中華電力有限公司
CLP Power Hong Kong Limited

Code of Practice 101 for Distribution Substation Design (COP101)
Update No. 4/2019 – New and Revised COP101 Drawings

Document:	COP101 Version 14
Effective Date:	10 December 2019
Summary of Change:	New and revised COP101 drawings are listed below and attached. 1. Revision of drawing - T-COP-10250-D-E33-0102-03-E-A (Concrete wall or steel supporting structure added to optimise cable routing.) 2. Revision of drawing - T-COP-10250-D-E33-0102-04-E-A (Concrete wall or steel supporting structure added to optimise cable routing.)) 3. Revision of drawing - T-COP-10250-D-E33-0103-16-E-A (Dimension of wicket door added.) 4. Revision of drawing - T-COP-10250-D-E33-0103-17-E-A (Dimension of wicket door added.) 5. Revision of drawing - T-COP-10250-D-E33-0103-18-E-A (Dimension of wicket door added.) 6. Revision of drawing - T-COP-10250-D-E33-0103-19-E-A (Dimension of wicket door added.) 7. Revision of drawing – T-COP-10250-D-E33-0103-29-B-A (Outlet of temporary supply cables updated.) 8. New drawing – T-COP-10250-D-E33-0103-40-A (Typical details of eyebolt Installation for L.V. board)

DRG. NO. T COP 10250 D E33 0103 19 E A

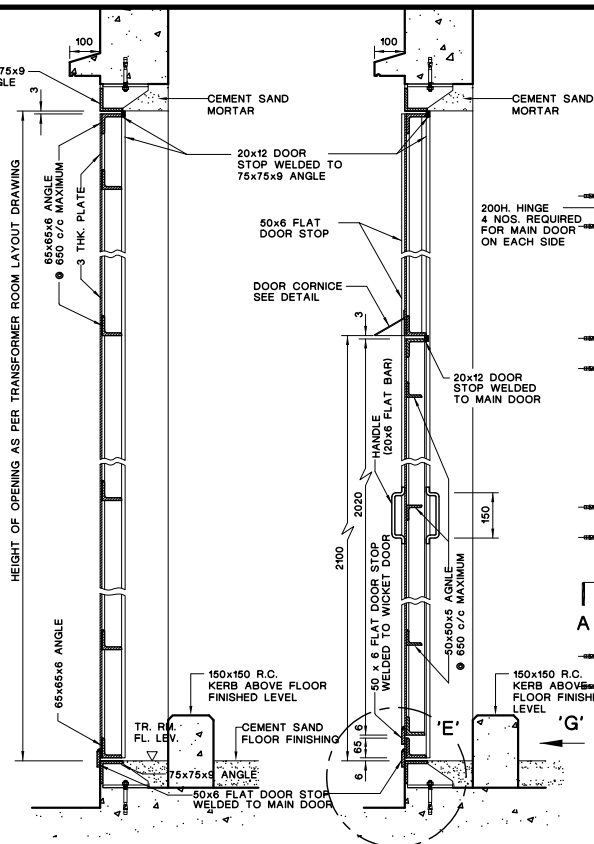
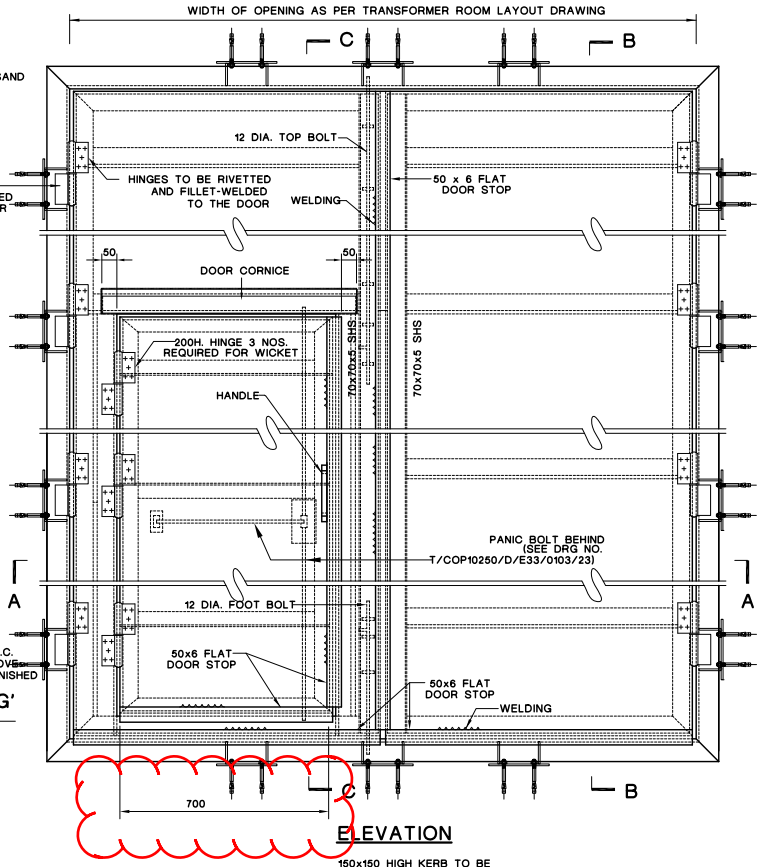
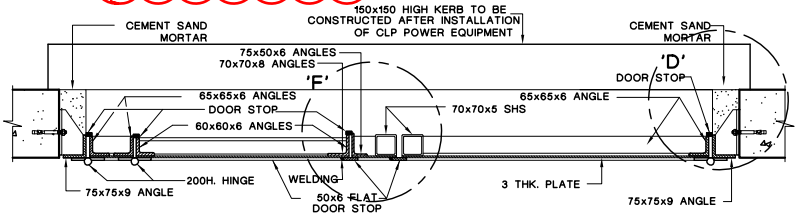
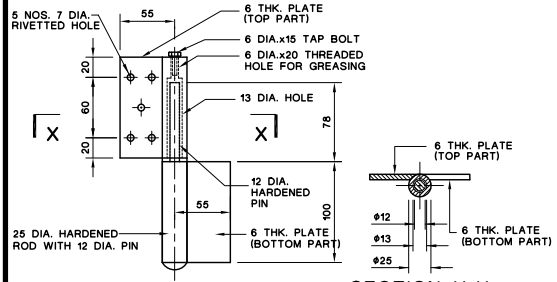
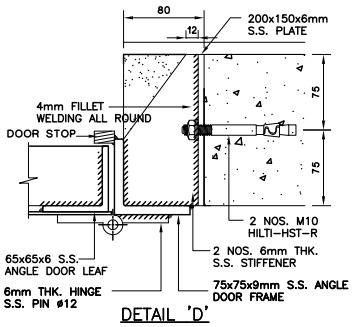
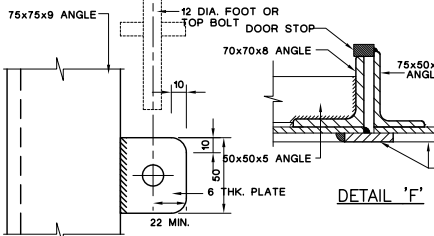
D	GENERALLY REVISED
C	AMENDMENT OF DESCRIPTION TO VIEW 'C'
E	DIMENSION ADDED

DRG. NO. T C O P 1 0 2 5 0 D E 3 3 0 1 0 3 2 9 B A

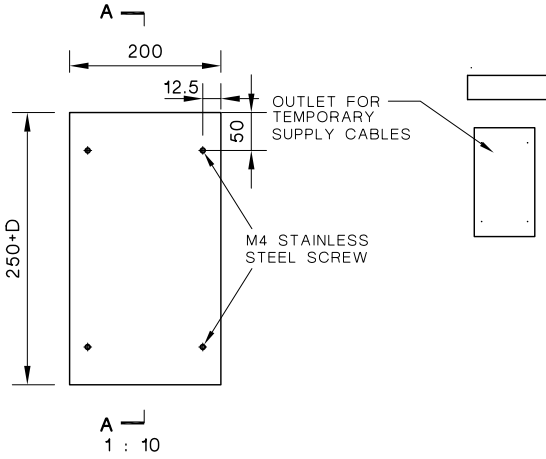
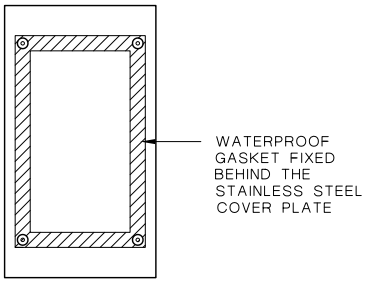
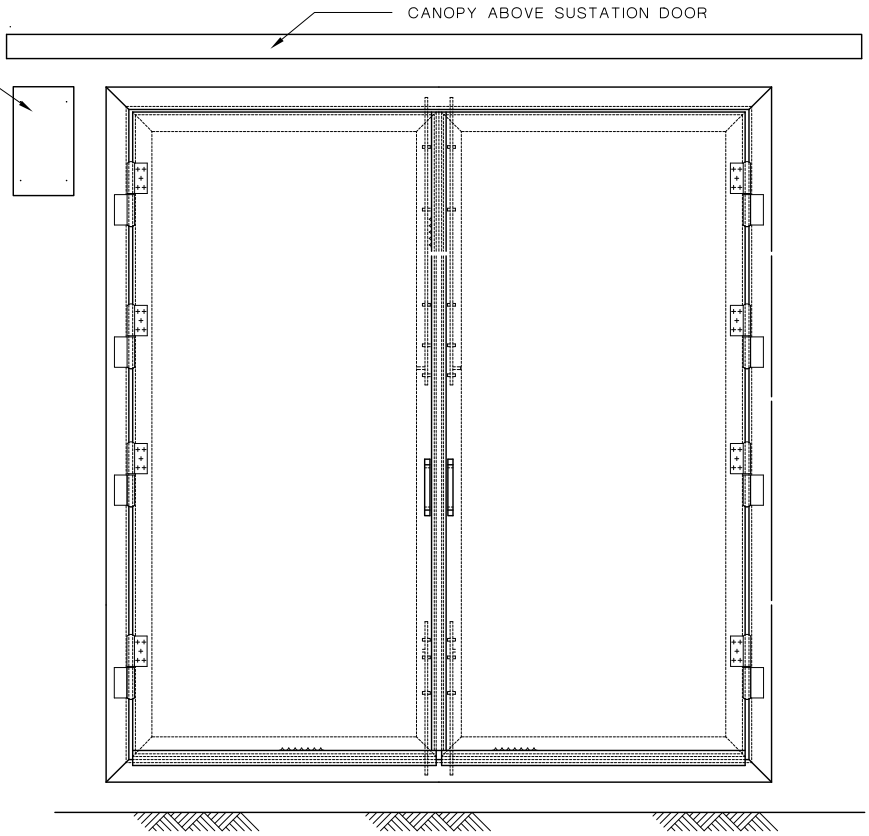
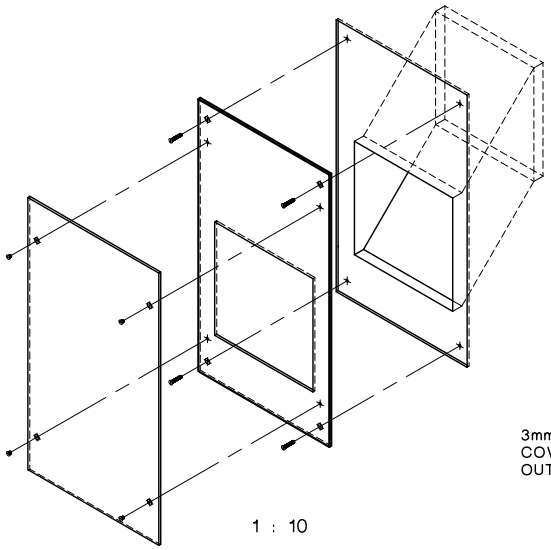
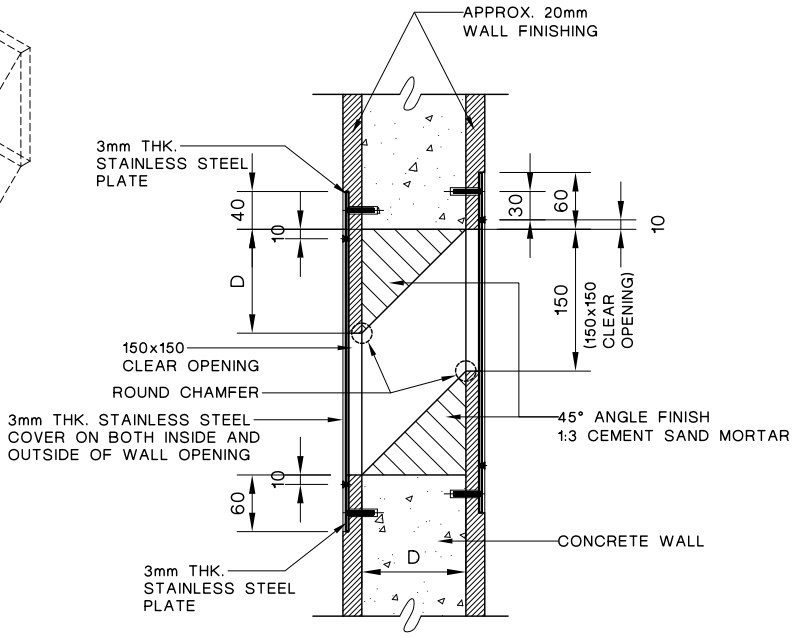
B	OUTLET OF TEMPORARY SUPPLY CABLES UPDATED	A	NOTES 1 UPDATED

DRG. NO. T COP 10250 D E33 0103 41 - A

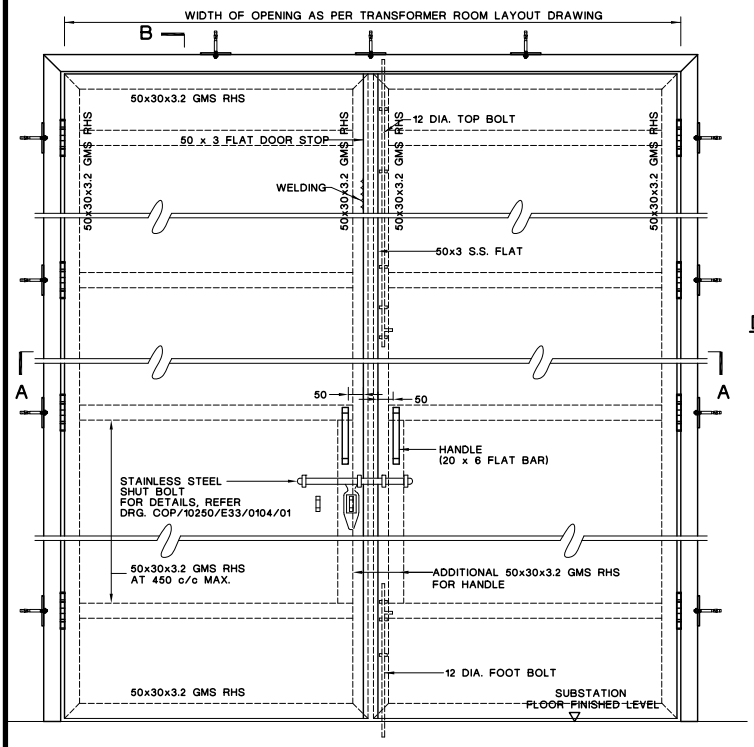
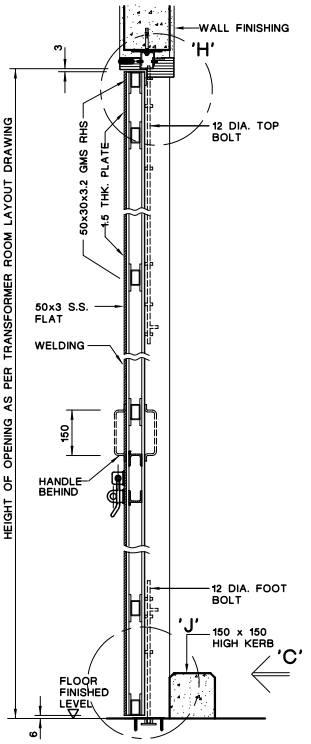
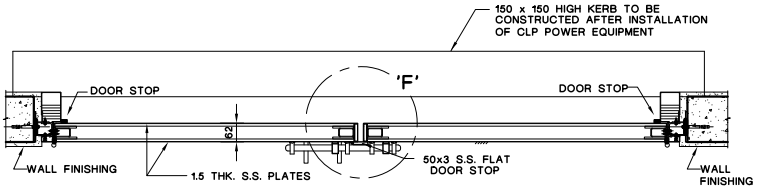
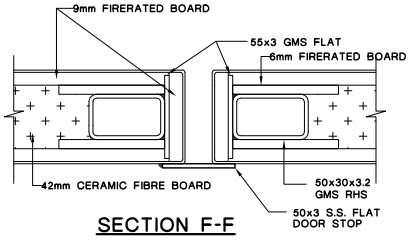
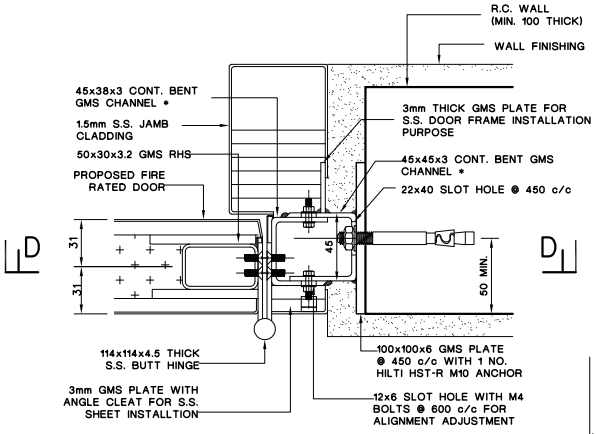
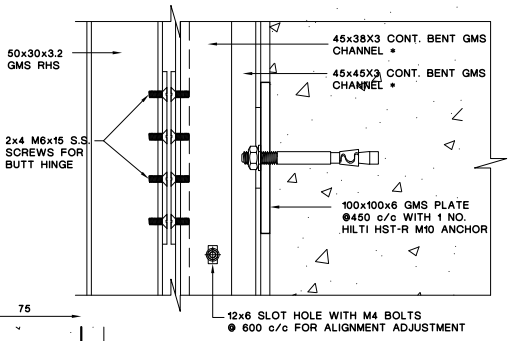
9. New drawing – T-COP-10250-D-E33-0103-41-A (Typical details of double leaf laminated steel door with shut bolt) 10. New drawing – T-COP-10250-D-E33-0103-42-A (Typical details of single leaf laminated steel door with shut bolt) 11. Revision of drawing – T-COP-10250-D-E33-0104-04-C-A (Note added.) 12. Revision of drawing – T-COP-10250-D-E33-0104-05-E-A (Note added.) 13. Revision of drawing – T-COP-10250-D-E33-0104-06-F-A (Note added.) 14. Revision of drawing – T-COP-10250-D-E33-0104-07-G-A (Note added.) 15. Revision of drawing – T-COP-10250-D-E33-0112-03-A-A (Vertical storage frame arrangement for 2700 length floodgate is deleted.)

DRG. NO. T C O P 1 0 2 5 0 D E 3 3 0 1 0 4 0 4 C A

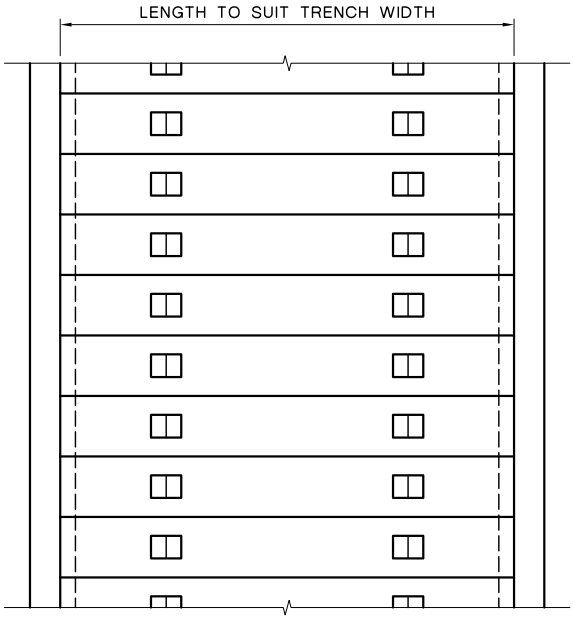
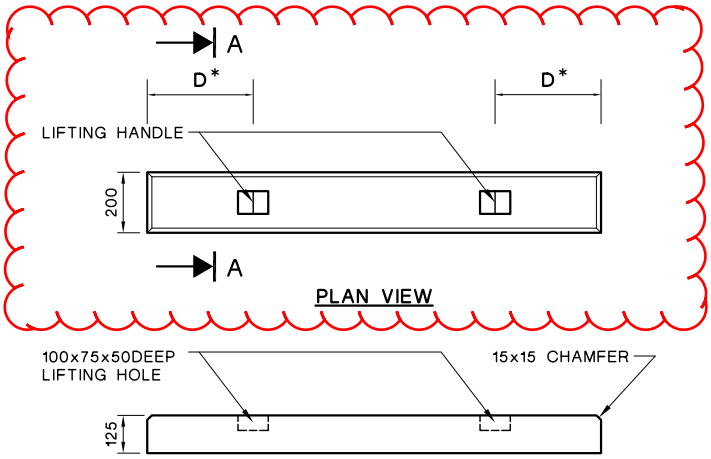
C	NOTE ADDED	B	GENERAL AMENDMENT	A	NOTES ADDED

DRG. NO. T C O P 1 0 2 5 0 D E 3 3 0 1 0 4 0 5 E A

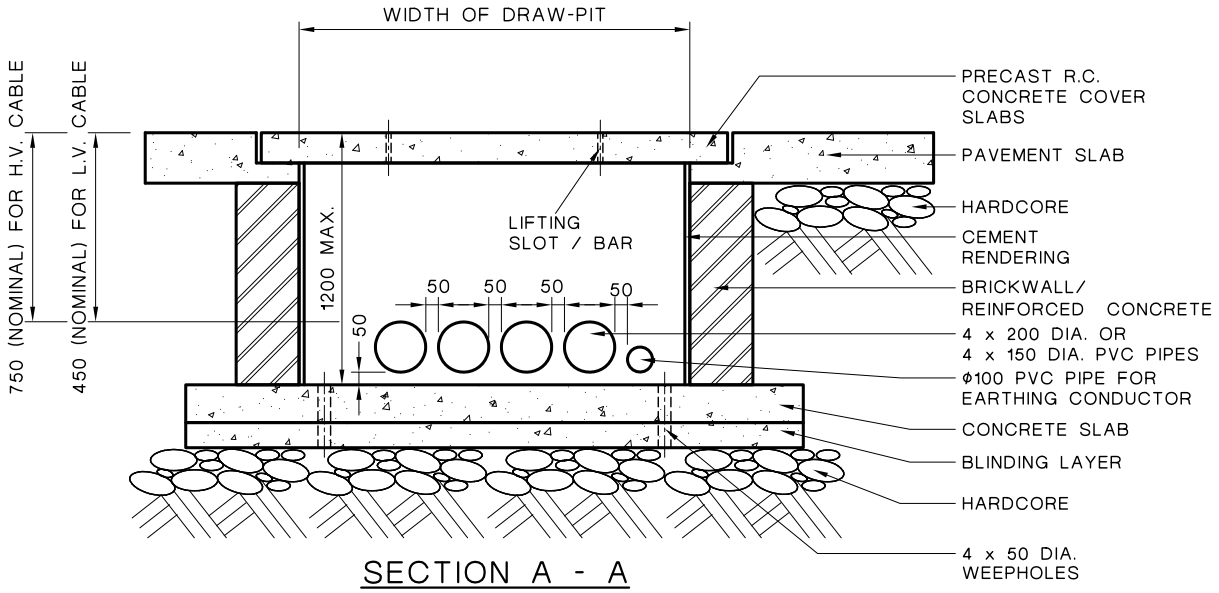
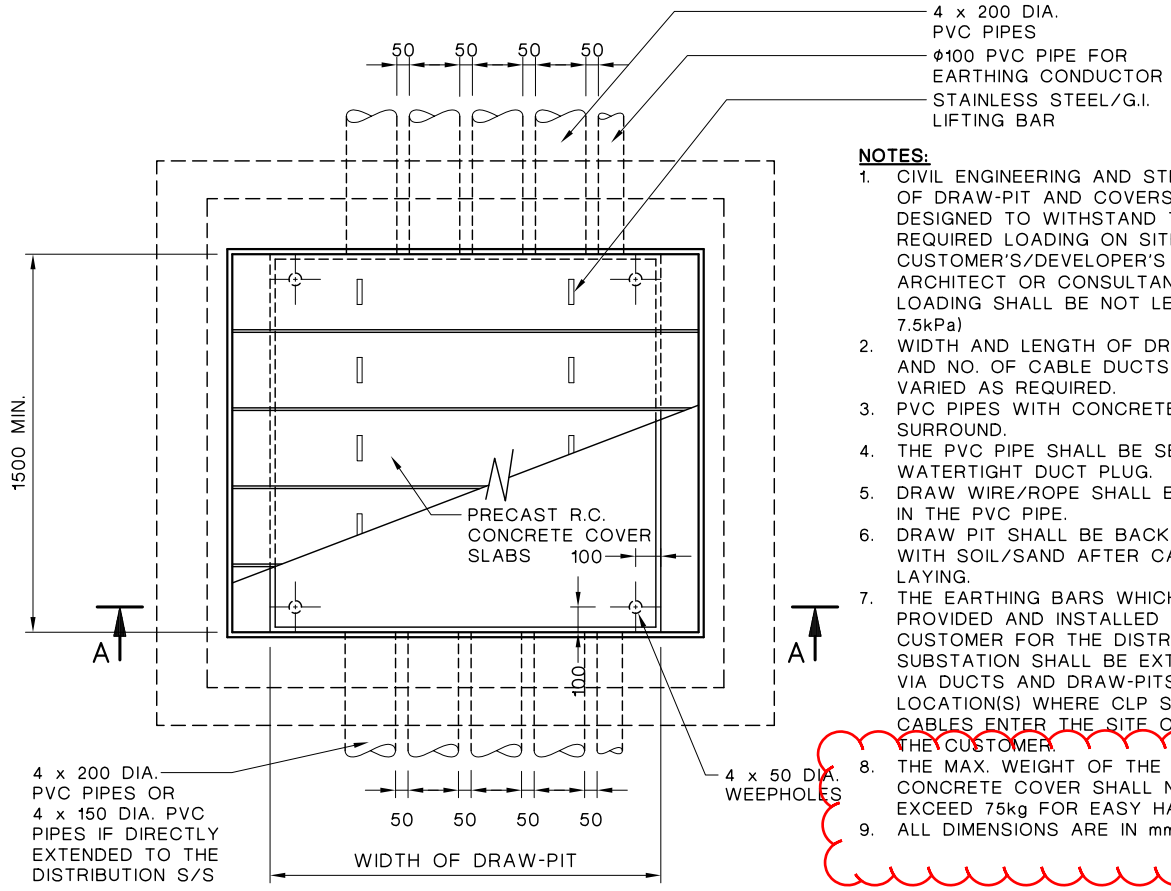
E	NOTES ADDED
D	PVC PIPE SIZE UPDATED, G.I. PIPE DELETED.

DRG. NO. T COP 10250 DE3 0104 06 F A

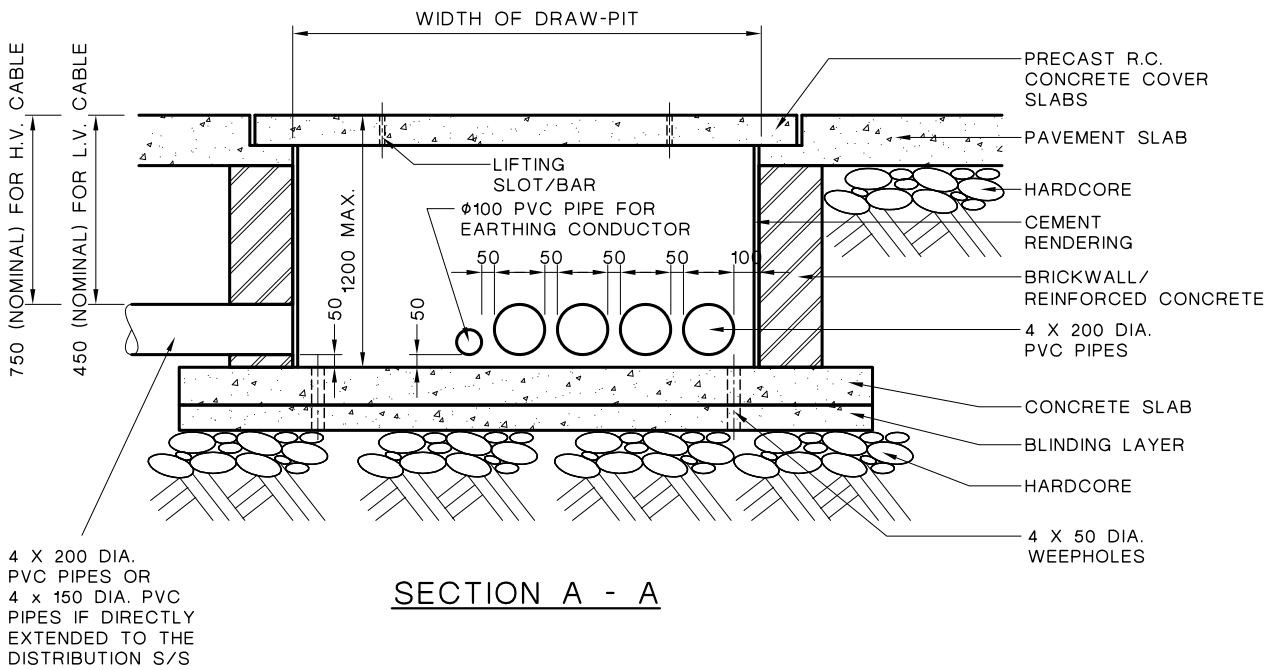
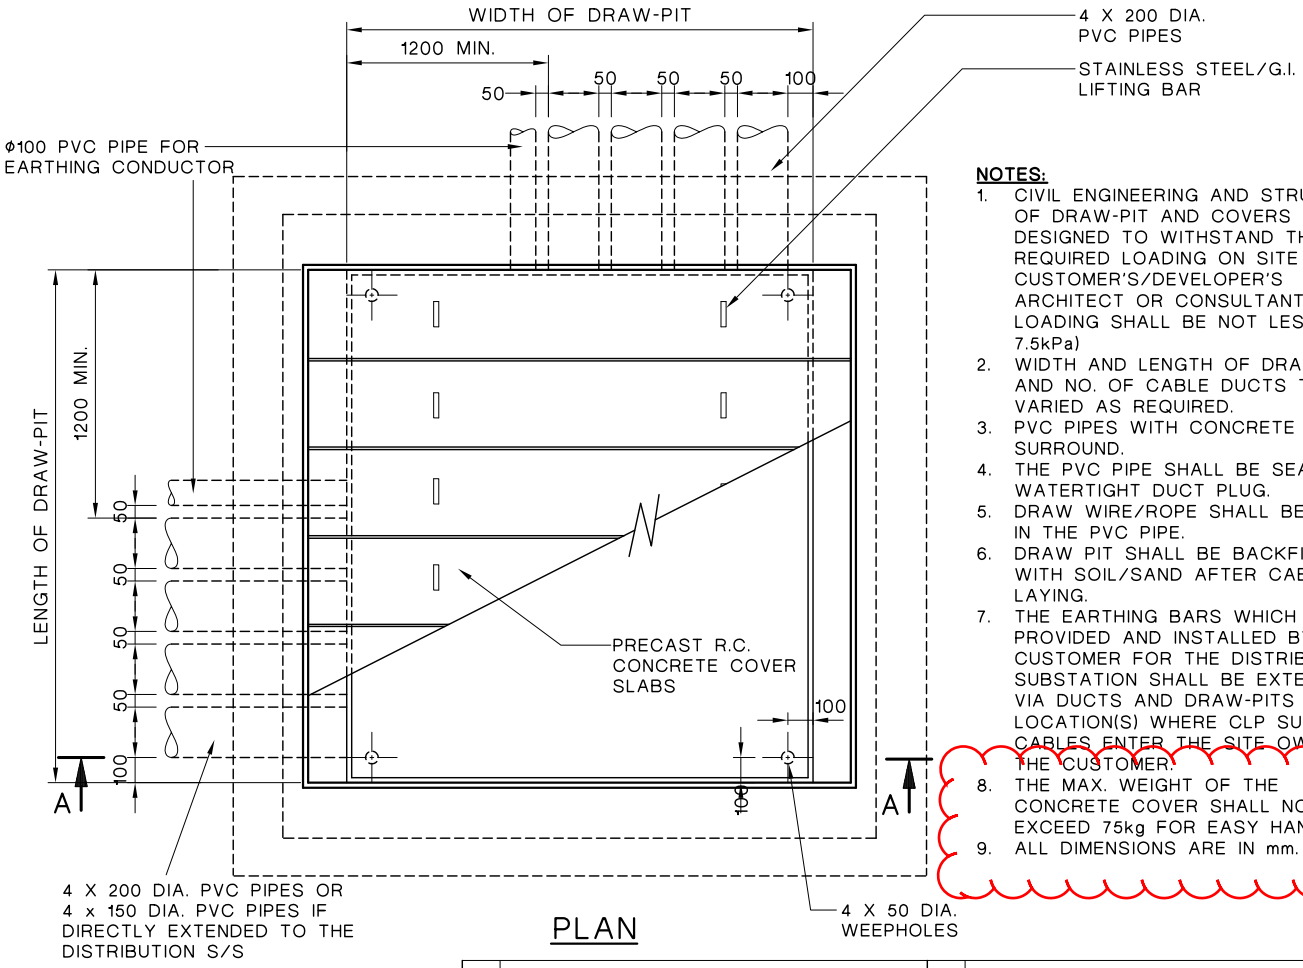
E	G.I. PIPE DELETED.	F	NOTES ADDED
